1987 - 1991 Corvette: Service Bulletin: 4L60 Low & Reverse Clutch New Plate Available

Subject: 4L60 LOW & REVERSE CLUTCH NEW WAVE PLATE IS AVAILABLE

Model and Year: 1987-91 CAPRICE, CAMARO, CORVETTE AND 1987-91 C/K, RN, S/T TRUCKS, G, M VANS AND 1990-91 L VAN WITH 4L60 AUTOMATIC TRANSMISSION

Bulletin Number: 91-186-7A - (01/29/1991)

DATE OF PRODUCTION CHANGE: (Figure 1)

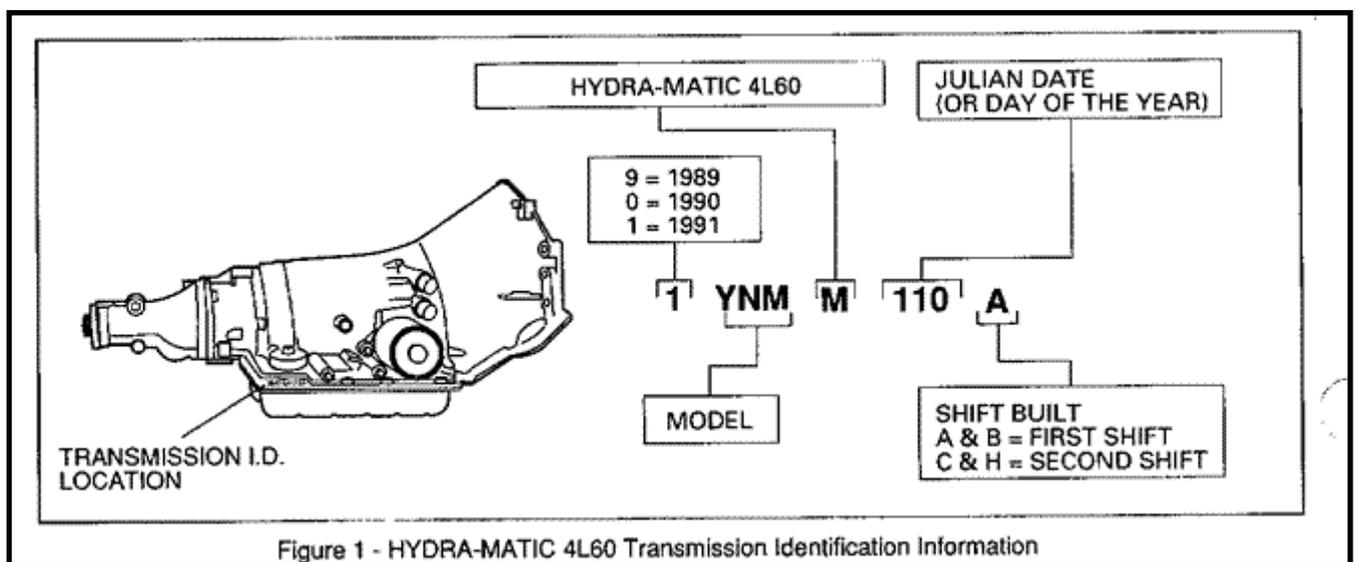
----- Beginning March 28,1990 (Julian Date 087), all HYDRA-MATIC 4L60 transmissions were built using the new low and reverse clutch wave plate.

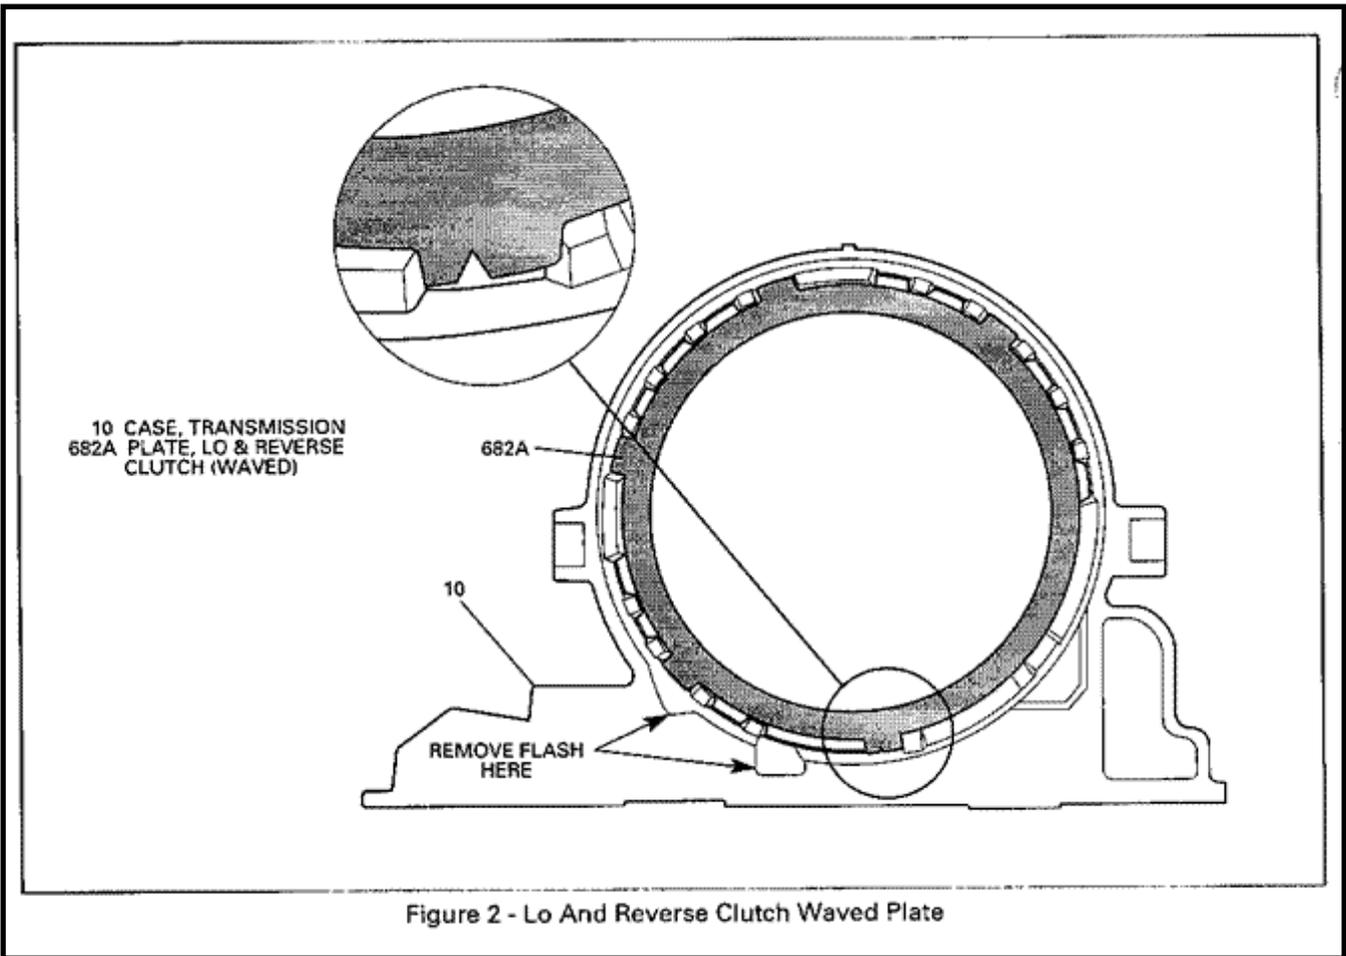
SERVICE INFORMATION: (Figure 2) ----- Low and Reverse Clutch failure can be caused by case casting flash interfering with clutch plate travel. A new wave plate is now available which will alleviate this condition. This new plate can be used to service any Hydra-matic 4L60 transmission produced after February 9, 1987 (Julian Date 040).

When installing the new wave plate, check for any case flash that may be present in the low and reverse grooves, and use a metal file to remove. See Figure 2 for case location information.
